Subject	7-Way Strain Relief Relocation					Number	24-003
						Date	9/15/2024
						Model	Solitude Fifth Wheels
						Build Date	11/1/21 - 2/28/23
Circulate To:	Service Manager	x	Parts Manager	x	Technician	x	
	Warranty Admin	x	Sales Manager	x	Part Number (s)	See Below	
Concern:	Current strain relief needs relocated to provide additional securement to the 7-way cord.						
Remedy:	Relocate the p-clamp, securing the 7-way cord 90 degrees, to enhance strain relief.						
Flat Rate:	920007

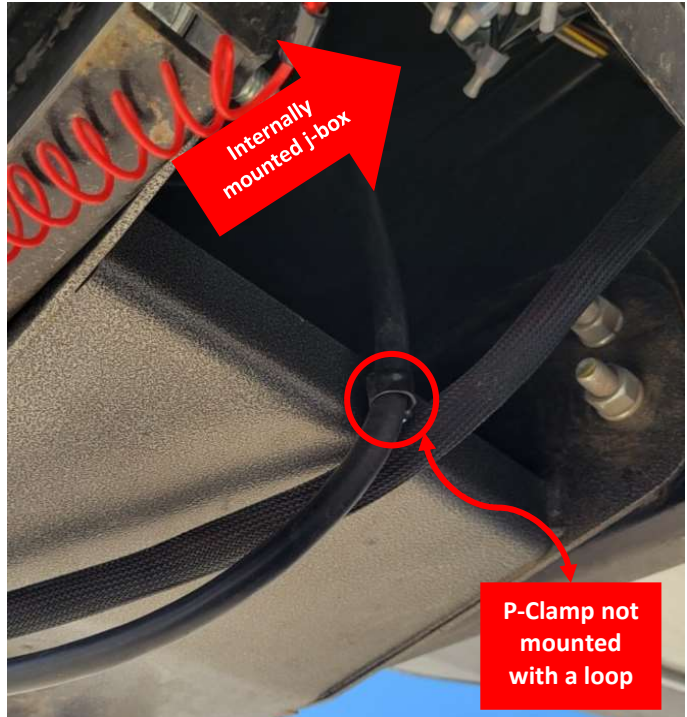
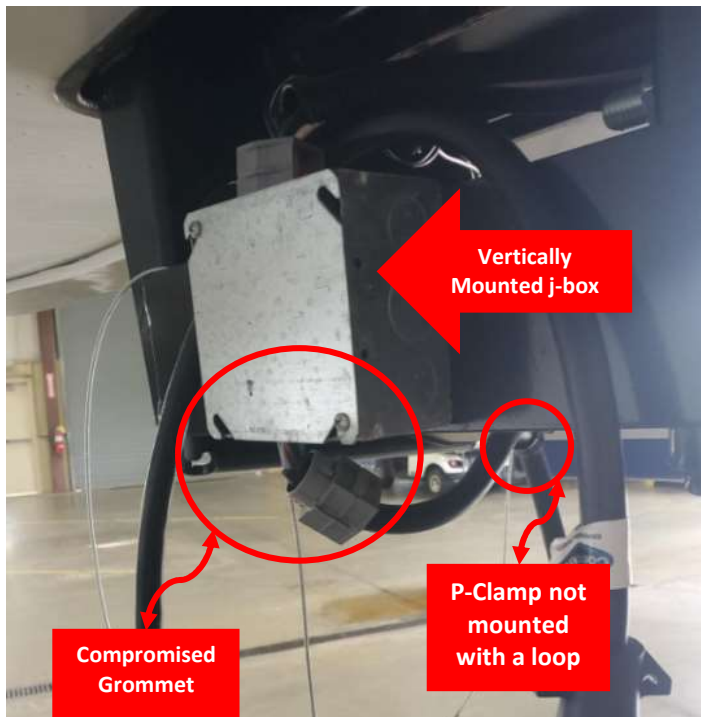
1) Inspect the RV to determine the position of the 7-way strain relief p-clamp. If the p-clamp is not oriented with a loop it will require relocation.

2) Move the strain relief p-clamp to the rear of the pinbox using the parts listed above. Create a loop as showing in the photos below. Ensure the grommets are secure in the junction box and the are both undamaged and the 7 way cord is long enough to reach the customer's tow vehicle without tension on the 7-way cord.**
